U.S. Nuclear Regulatory Commission
Washington, DC 20555-0001
ATTN: Document Control DeskLimerick Generating Station, Units 1 and 2
Renewed Facility Operating License Nos. NPF-39 and NPF-85
NRC Docket Nos. 50-352 and 50-353

Subject: Supplement - Application to Implement an Alternate Defense-in-Depth Categorization Process, an Alternate Pressure Boundary Categorization Process, and an Alternate Seismic Categorization Process in Accordance with the Requirements of 10 CFR 50.69, "Risk-Informed Categorization and Treatment of Structures, Systems and Components for Nuclear Power Reactors"

Attachment 1: License Amendment Request Supplement - Application to Implement
Alternate Categorization Processes in Accordance with the Requirements of
10 CFR 50.69.

Attachment 2: Revised Proposed FOL Appendix C License Condition Mark-ups

Figure 1: GMRS and SSE Response Spectra for Limerick¹

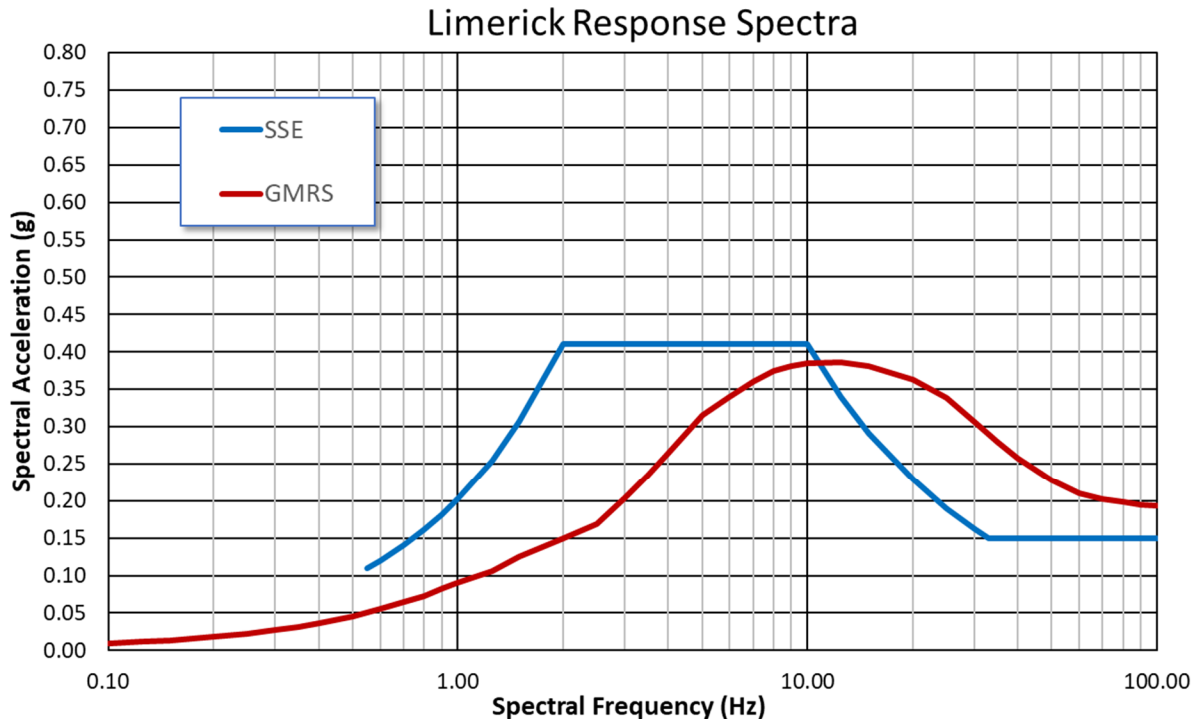
As shown in Figure 1, comparing the Limerick GMRS (derived from the seismic hazard) to the SSE (i.e., seismic design basis capability), the GMRS is below the SSE up to approximately 11 Hz and exceeds the SSE above 11 Hz up to 100 Hz (Reference [25]). The NRC screened out Limerick from performing a seismic PRA in response to the NTTF 2.1 50.54(f) letter (Reference [26]). As such, it is appropriate that Limerick is considered a Tier 1 plant; however, as previously mentioned, Exelon is submitting Limerick as a Tier 2 site in order to address NRC concerns. The basis for Limerick being Tier 2 will be documented and presented to the IDP for each system categorized.

Figure 2: Categorization Process Overview³

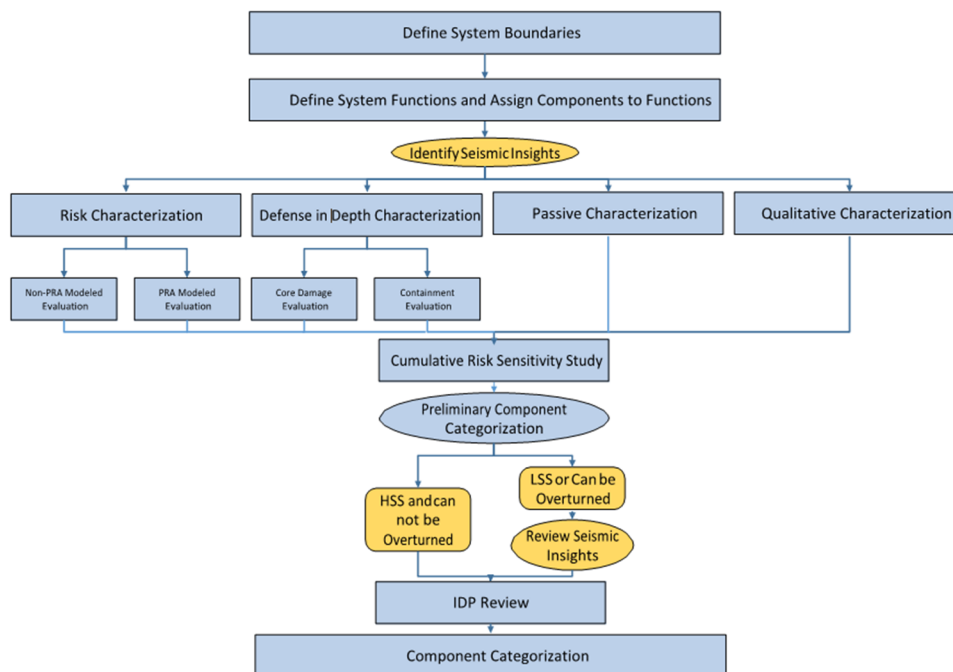
At several steps of the categorization process, (e.g., as noted in Figure 2 and Table 1) the categorization team will consider the available seismic insights relative to the system being categorized and document their conclusions in the SCD. Integrated importance measures over all modeled hazards (i.e., internal events, including internal flooding, and internal fire for Limerick) are calculated per Section 5.6 of NEI 00-04, and components for which these measures exceed the specified criteria are preliminary HSS which cannot be changed to LSS. For HSS SSCs uniquely identified by the Limerick PRA models but having design basis functions during seismic events or functions credited for mitigation and prevention of severe accidents caused by seismic events, these will be addressed using non-PRA based qualitative assessments in conjunction with any seismic insights provided by the PRA.

³ Figure 2 is an update to Figure 5-1 in Reference [39].

Figure 3: Seismic Correlated Failure Assessment for Tier 2 Plants⁵

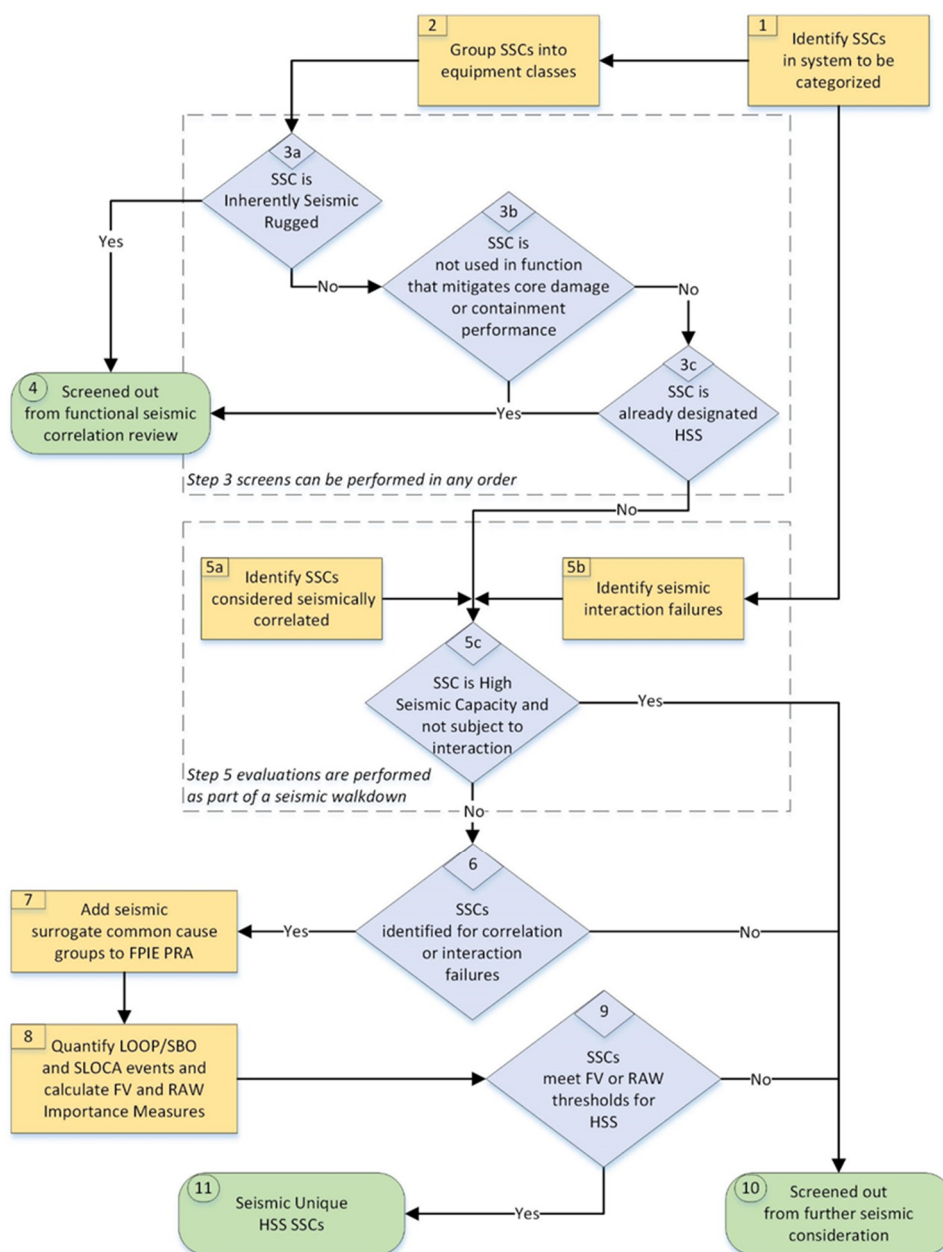
For each system categorized, the categorization team will evaluate correlated seismic failures and seismic interactions between SSCs. This process is detailed in Reference [3] Section 2.3.1 and is summarized in Figure 3.

⁵ Reproduced from Reference [3] Figure 2-3 including the markups provided in Attachment 2 of References [9] and [10].
